G.O., No. 61, 5th February 1907.

American Mission Hindu Girls' School at Chittoor.

Sanctioning, subject to certain conditions, a maximum grant of Rs. 1,500 towards the cost of constructing a building for the —.

NOTE BY TECHNICAL SECTION.

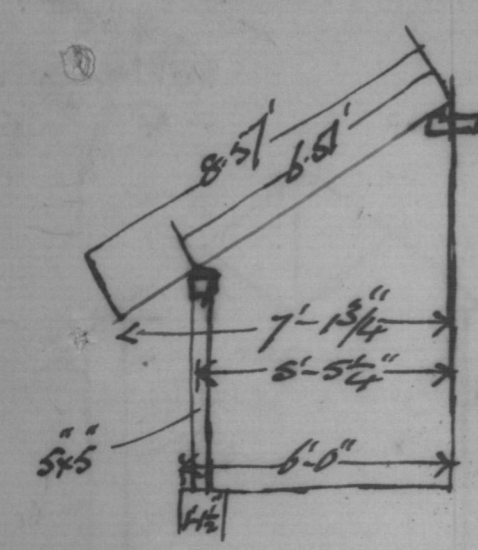
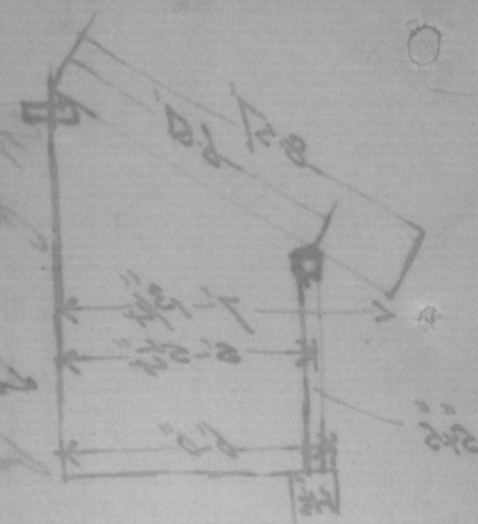
a girder $15 \times 5 \times 42$ lbs is the most

suitable against $14 \times 6 \times 57$ lbs

provided in the estimate. A

similar girder is found to be

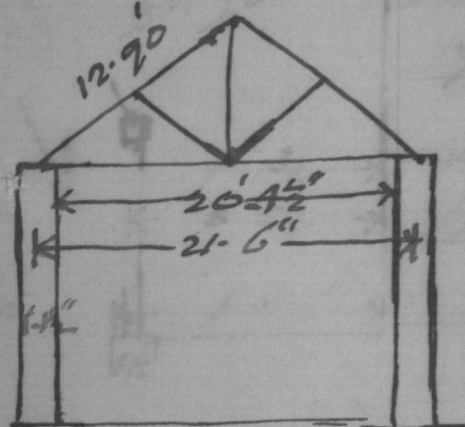
Quandah - flat and
pan tile roof.
Rafters - 12 ft Centre.
Load = $6.57 \times 12 \times 30 = 293$
 $W^3 = \frac{WL^2}{140} = \frac{293 \times (6.57)^2}{140} = 86$
Make Section $2 \times 3 \frac{1}{2}$
Inch with 2×4
Purlins - unsupported
Length = 7'-10" nearly
Load = $7 \frac{5}{8} \times 5.31 \times 30 = 1248$
Rafters = $6 \times 5.31 \times \frac{1}{6} \times \frac{7}{24} \times 46 = 74$
Stress 1312
 $W^3 = \frac{WL^2}{140} = \frac{1312 \times (7 \frac{5}{8})^2}{140} = 574$
Make Section $4 \times 5 \frac{1}{4}$
Inch with 5×6
Wall purlins - on Corbel Stones $5 \frac{3}{8}$
ft Centre.
Load = $5 \frac{3}{8} \times 3 \frac{1}{4} \times 30 = 524$
Rafters = $4 \times 3 \frac{1}{4} \times \frac{1}{6} \times \frac{7}{24} \times 46 = 46$
Stress 570
 $W^3 = \frac{WL^2}{140} = \frac{570 \times (5 \frac{3}{8})^2}{140} = 117$
Make Section $3 \times 3 \frac{1}{2}$
The upper ends of the
rafters should not be let into the
walls - they should be nailed

onto wall purlins supported
on Corbel Stones.

vis. moved
always done
Ys. H.
25th.
